**Chemung County Stormwater
Construction Inspection
Erosion and Sediment Control**

Project Name Southern Tier Logistics	Date 7-25-2022
Location Industrial Park Village of Horseheads	Permit # NYR11J885
Weather Conditions sunny humid	Entry Time: 8:37 am
On-Site Representative Present: Christina Pierce, LCP; Bob Young, Village	Exit Time: 10:05 am

PROJECT: So. Tier Logistics
Village of Horseheads
Municipal Construction Insp.
July 25, 2022

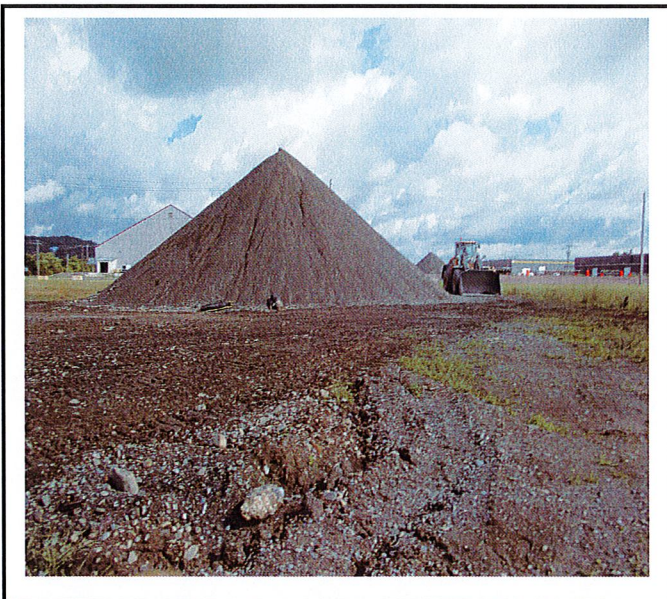
Concrete washout requires maintenance or replacement.

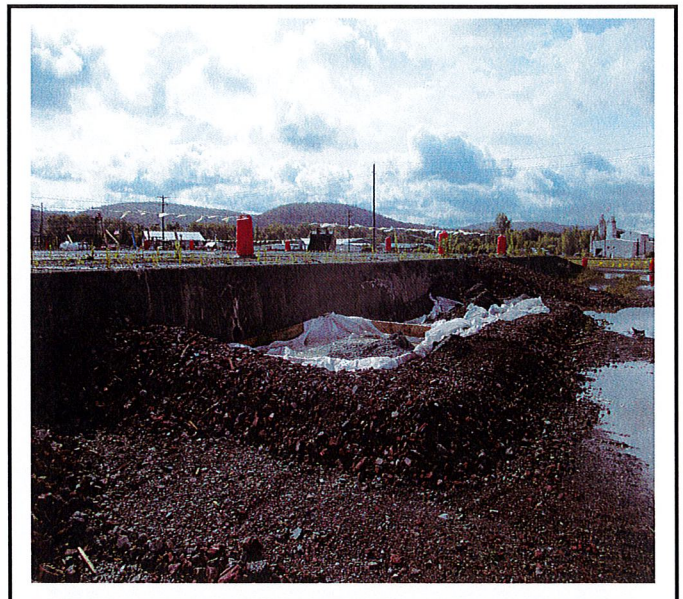
Silt fence being re-installed around soil stockpile at the time of inspection.

Concrete washout requires maintenance or replacement.
